**Re: Bottle Rock Power Plant (79-AFC-4C)
Compliance Submittal - Condition of Certification 10-5**

Condition of Certification ("COC") 10-5, related to *Structural Engineering*, requires the project owner to file with the CEC Compliance Project Manager ("CPM") substantial design changes to the final plans as required by CBSC 2001. "Substantial changes" are defined to include "all changes requiring an alteration in design concept and preparation of new design plans consistent with the [Application for Certification] conditions of certification..." Therefore, the following changes are considered "substantial" pursuant to COC 10-5. As such, BRP submits the enclosed detailed information in compliance with COC 10-5 regarding the following:

BOTTLE ROCK POWER CORPORATION (BRPC) VACUUM PUMP INSTALLATION

GENERAL PLAN

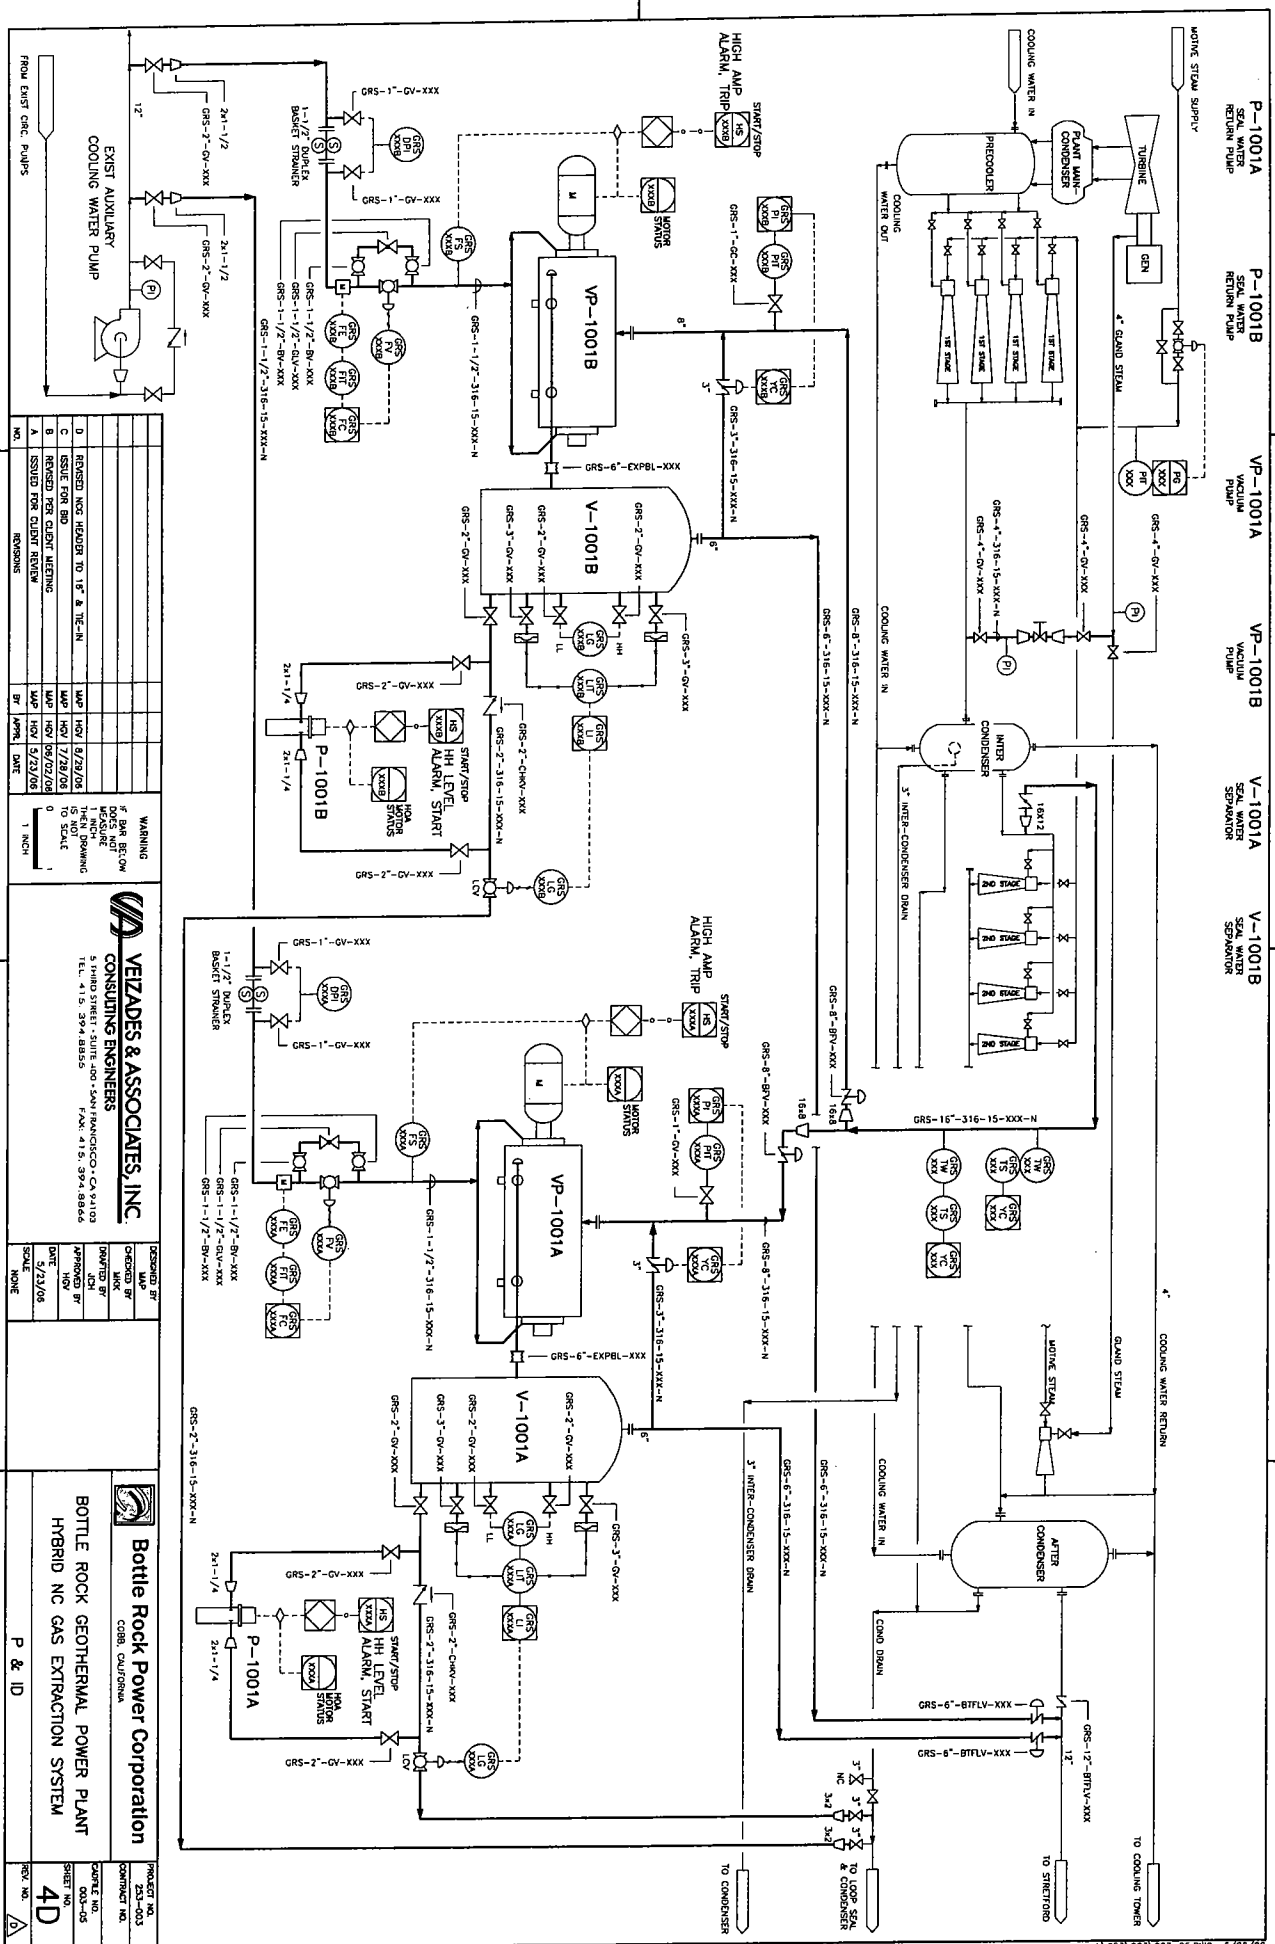
BRPC is recommending that two 50% capacity vacuum pumps be installed at the facility to assist in the removal of non-condensable gas (NCG). The current NCG removal system is two stages of ejectors. The existing ejector system will be rebuilt and will remain fully functional and serve as a backup system to the proposed vacuum pumps. The seal water from the vacuum pumps will be returned to either the hot-well or to the rich condensate system (both options are currently piped and available). Vacuum pumps are slightly more energy efficient than the ejectors but the main advantages to the plant are as follows:

- The use of vacuum pumps will significantly reduce (almost eliminate) the need to vent unabated steam or NCG's during a plant start. Vacuum can be pulled with the pumps and then the steam line warmed up through the turbine bypass directly to the condenser.
- The vacuum pumps will forward the NCG stream to the Stretford Process at a higher pressure. This will reduce back pressure shut downs and problems caused by minor restrictions (plugging) in the Stretford.
- Vacuum pumps produce less ambient noise than ejectors.

Please see attached drawing showing pumps installed with existing ejectors.

Figure 1. Control System Overview

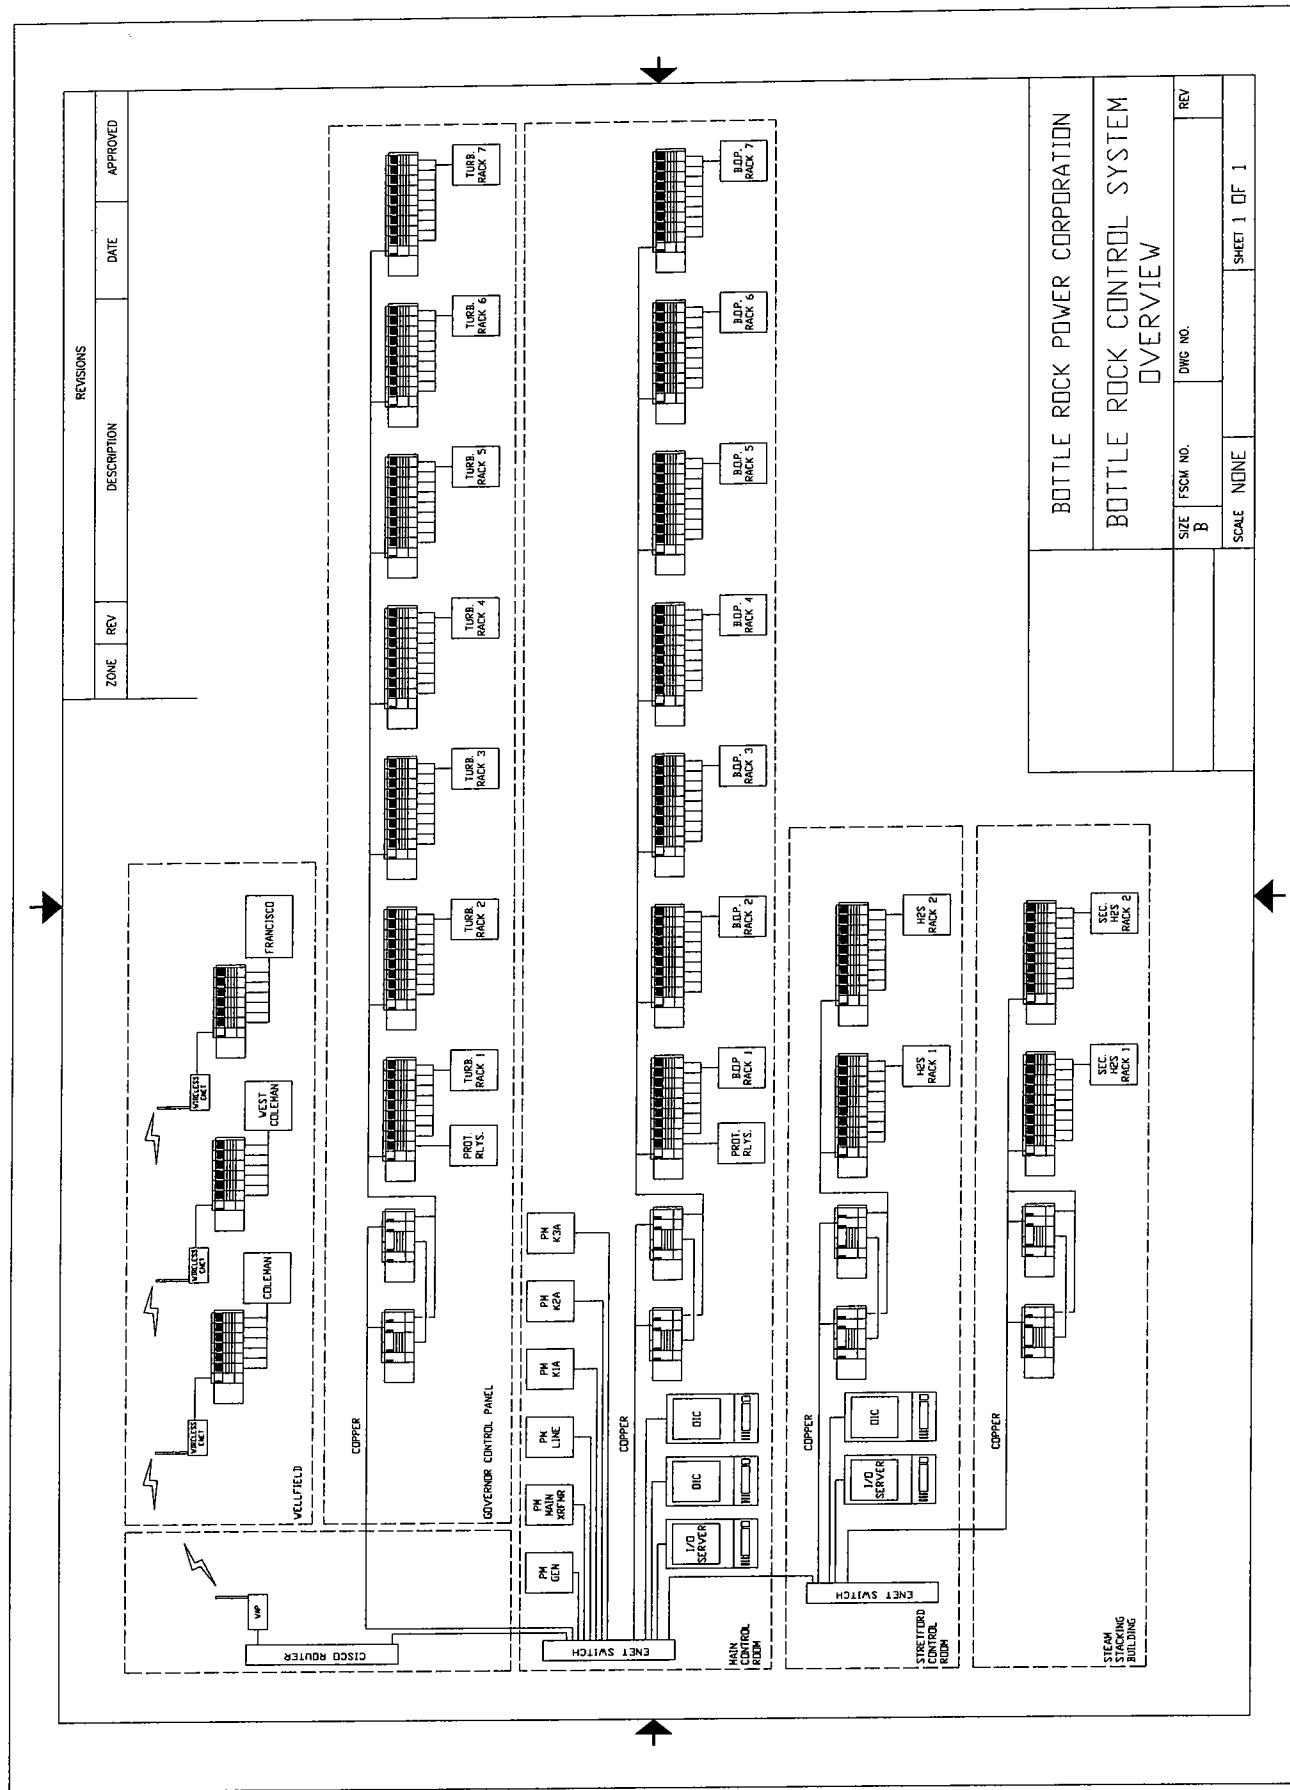
The proposed system implementation for the Bottle Rock project is outlined in Figure 1. Redundant ControlLogix processors and power supplies on the turbine/generator, balance of plant, and H₂S abatement control subsystems provide bumpless switchover to the backup process assembly in the highly unlikely event of a processor or power supply failure. Communications between the processors and their associated I/O modules is accomplished using Allen Bradley ControlNet protocol, allowing high speed, deterministic bi-directional transfer of time critical data. The ControlNet protocol also

CARBON FILTER INSTALLATION

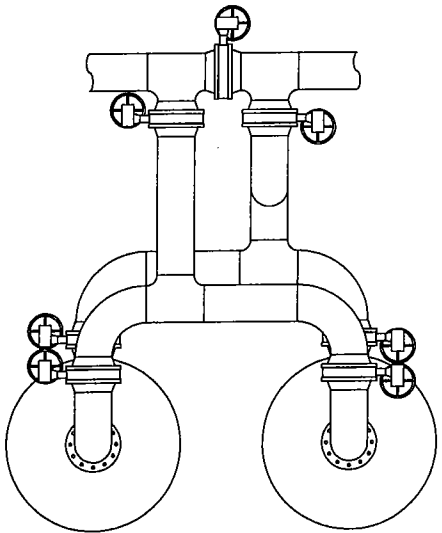
The plant proposes adding one (and in the future possibly a second) 100% flow, carbon bed filters to aid in the removal of mercury from the non-condensable gas stream. The size is yet to be determined but will be approximately 120 cubic feet of carbon.

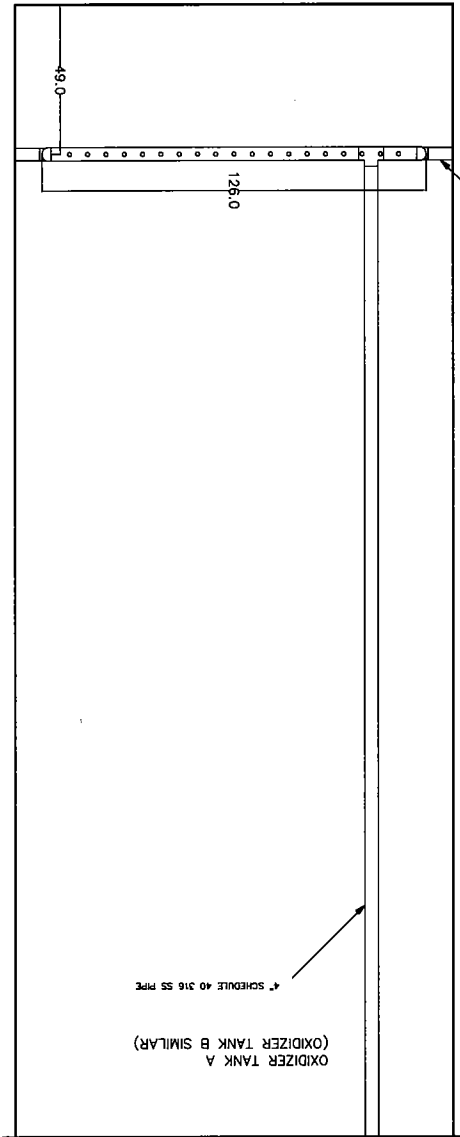
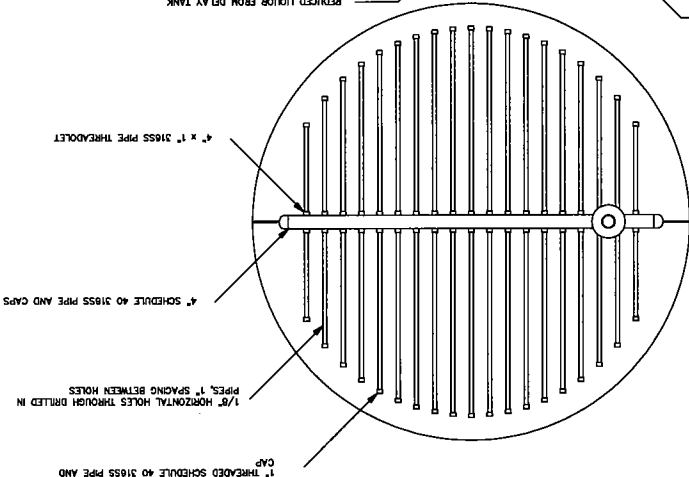
Air is currently introduced into the oxidizer tanks at four mixing venturis per tank. Atmospheric air commingles with Stretford solution that is discharging into the delay tank. The air and Stretford solution enters the delay tank about 4' off the bottom of the tank. The venturis have a tendency to plug due to small amount of elemental sulphur precipitating out at this point.

The plant proposes adding a sparging header inside each tank about 5' off the bottom. This header will deliver air more evenly and will potentially eliminate the plugging that occurs in the venturis. The original delivery system described above will remain in place and fully functional.

BOTTLE ROCK POWER US RENEWABLES GROUP HIGH VALLEY ROAD		CONDENSATE SPARGING SYSTEM	
		SIZE: B FILE NAME: BRP-MECH-CT-SPG-001.DWG SCALE: NONE	DWG NO.: BRP-MECH-CT-SPG-001 SHEET 1 OF 1

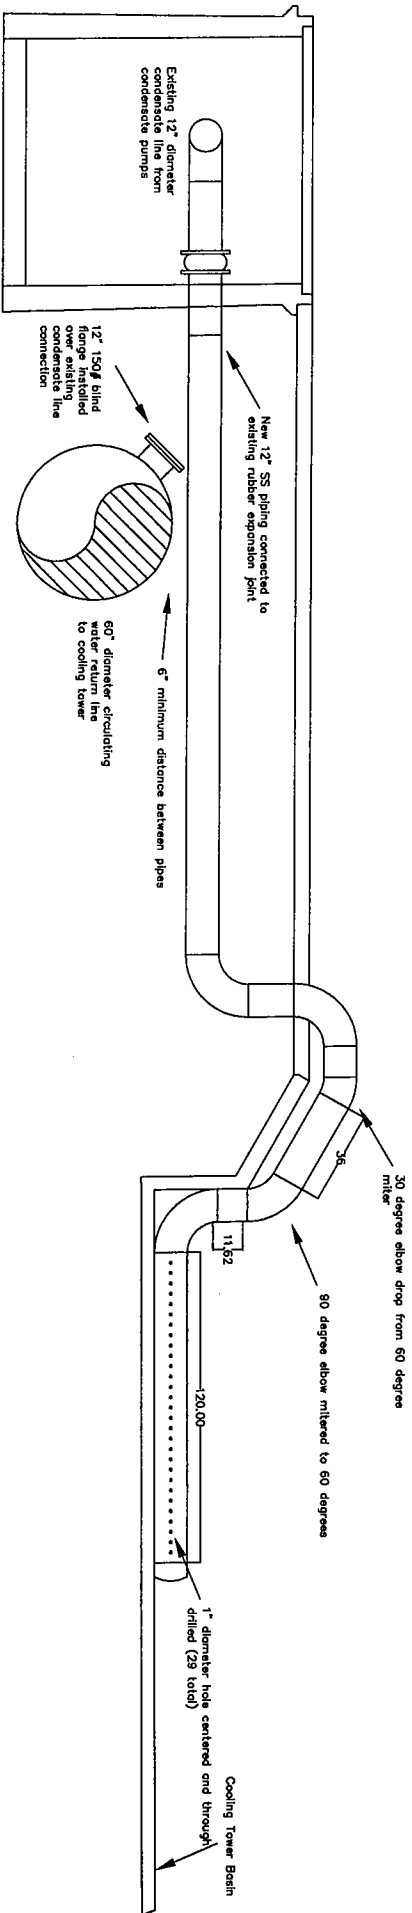
Per the request of LCAQMD the plant is submitting a design for returning hotwell condensate directly to the cooling tower basin and dispensing the condensate through a distribution header. Also, BRPC currently has multiple options for routing the condensate: (A) Commingle the condensate with the circulating water just prior to the cooling tower risers. (B) Commingle the condensate with the circulating water at the discharge of the condenser. (C) Commingle the condensate with the circulating water at the inlet to the condenser. (D) In combination with any of the above listed condensate flow paths, up to 50% of the hotwell condensate can be reinjected through a spray header into the vacuum side of the main condenser. Thus offering an additional opportunity to volatilize entrained hydrogen sulfide.
